Submission of Further Information (FI)

**Temporary Animal Boarding Establishment with Ancillary Facilities and associated
Filling of Land for a period of 5 years in "Agriculture" Zone,
Lot Nos. 1493 (Part) and 1500 (Part) in D. D. 107 and Adjoining
Government Land, Yuen Long, New Territories
(Application No. A/YL-KTN/1177)**

Further Information for Planning Application No. A/YL-KTN/1177**Response-to-Comments****Comments from Transport Department**

Plan Showing Location for Loading / unloading

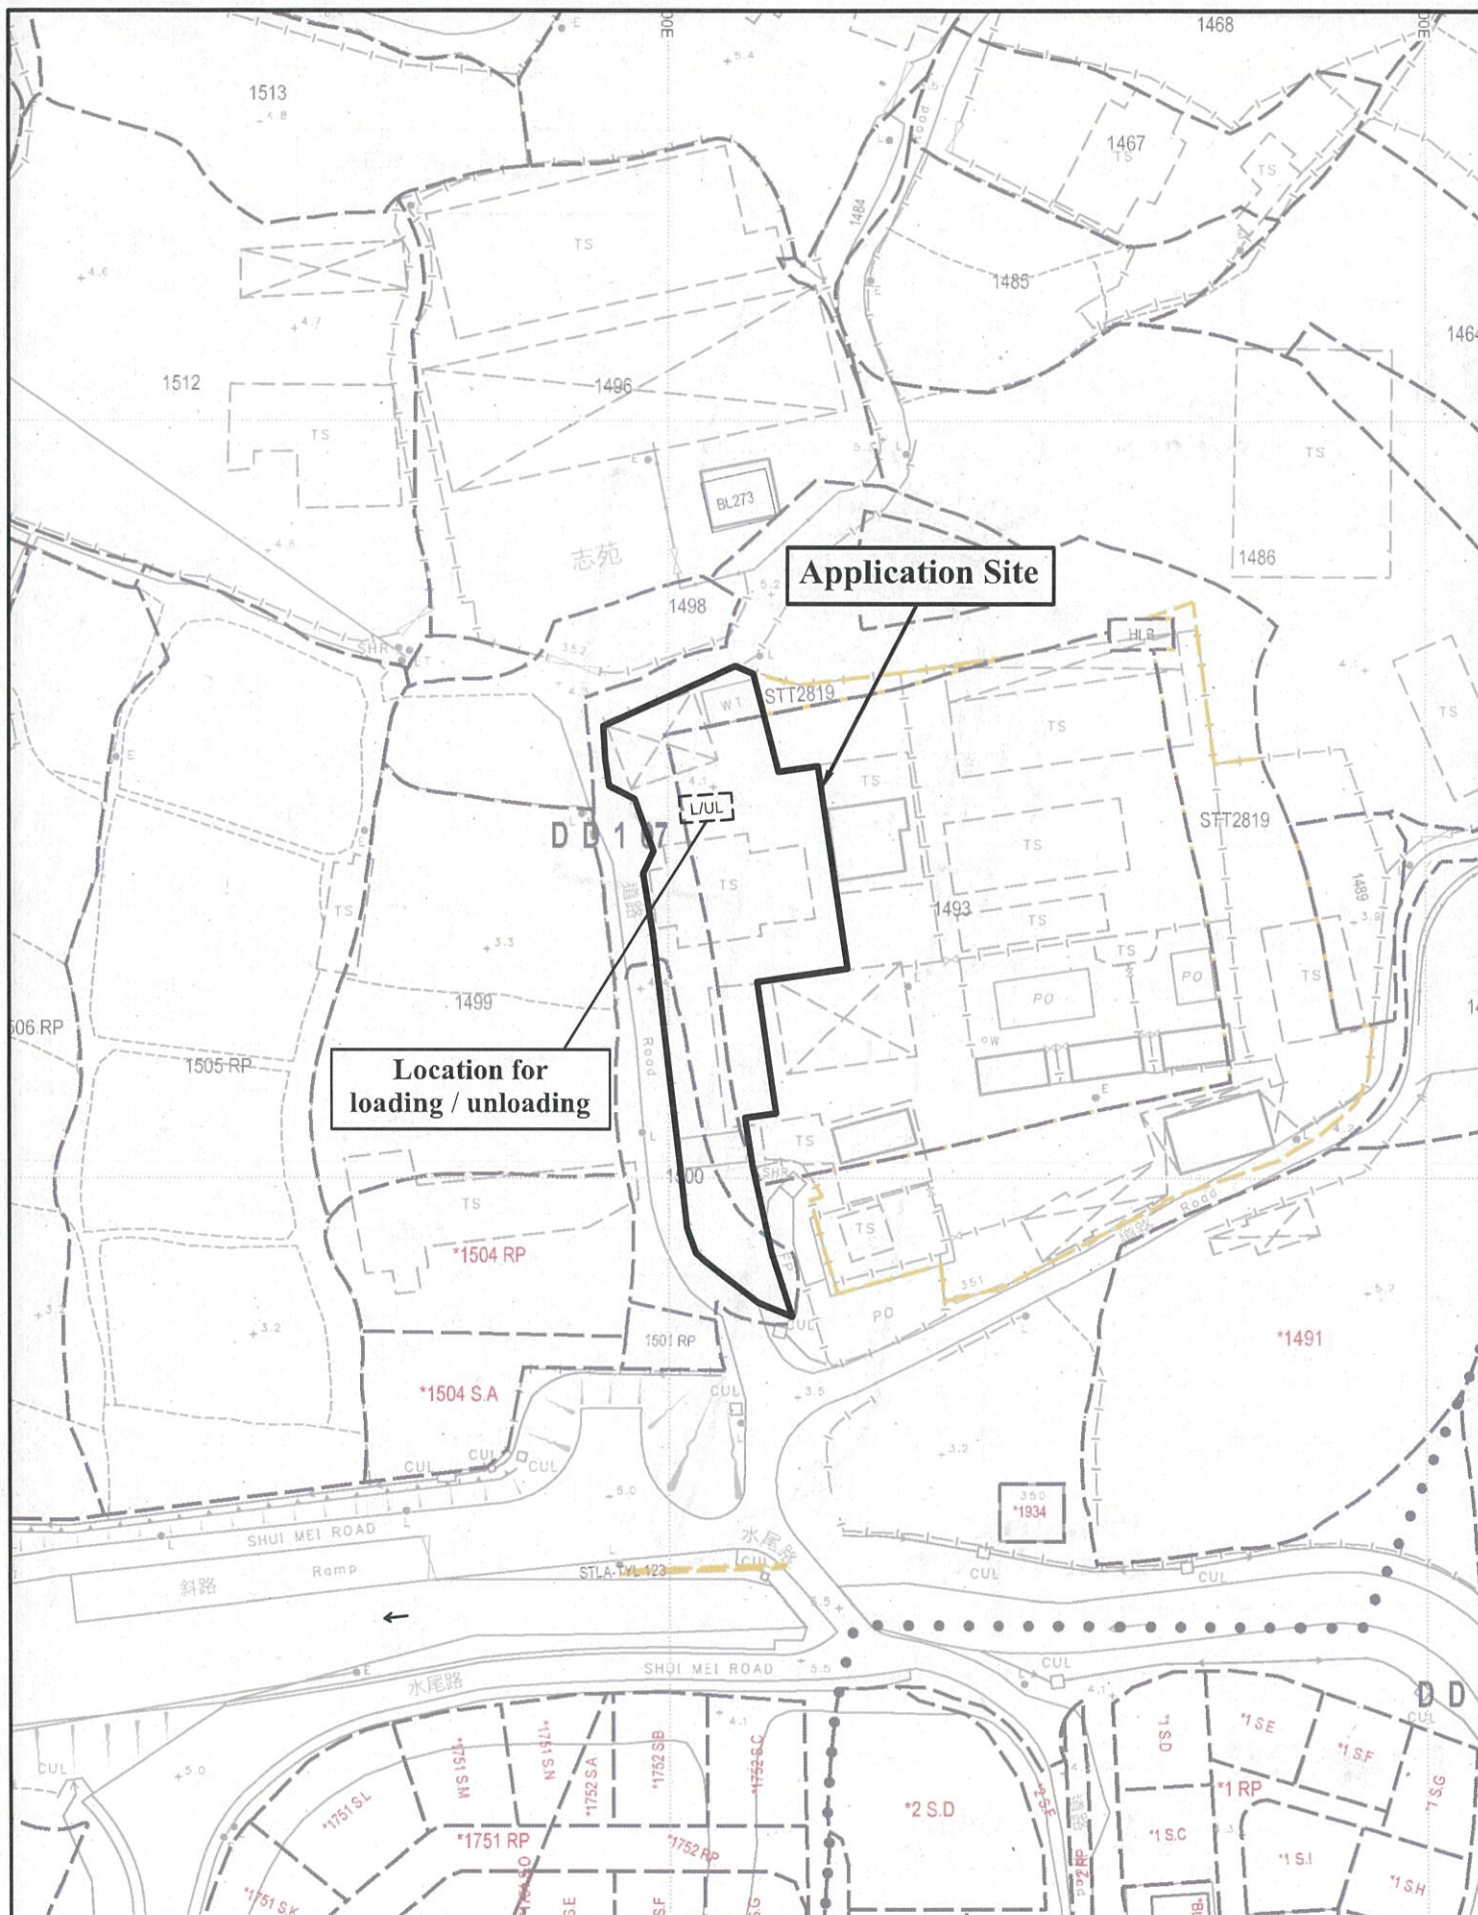
I.	Comments	Responses
1.	The proposed loading / unloading is located outside the site area. The applicant shall seek comments from relevant government department who is managing and maintaining that area.	The proposed loading / unloading area is revised. Please refer to the updated Plan showing Location for Loading / Unloading (Plan 8a), Swept Path Analysis (Plan 11) and the video of a trial run for details.
2.	The applicant should note the local access between Castle Peak Road - Tam Mi and the site is not managed by this Department.	Noted.

Viewpoint 10

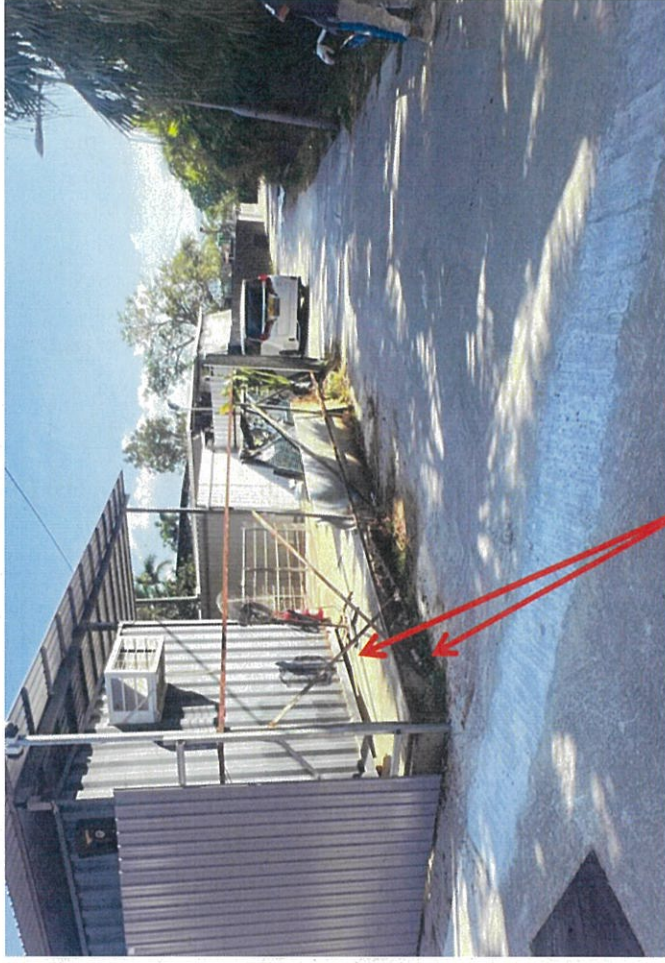
The updated drainage proposal is to reflect the actual situation. The local track at the north has had a lower ground level than the application site for many years. The surface runoff from the local track will not flow to the application site. Please refer to attached photograph (viewpoint 10) for consideration.

The ground level of the Site has been higher than the local track for many years. The surface runoff from the local track will not flow to the Site.
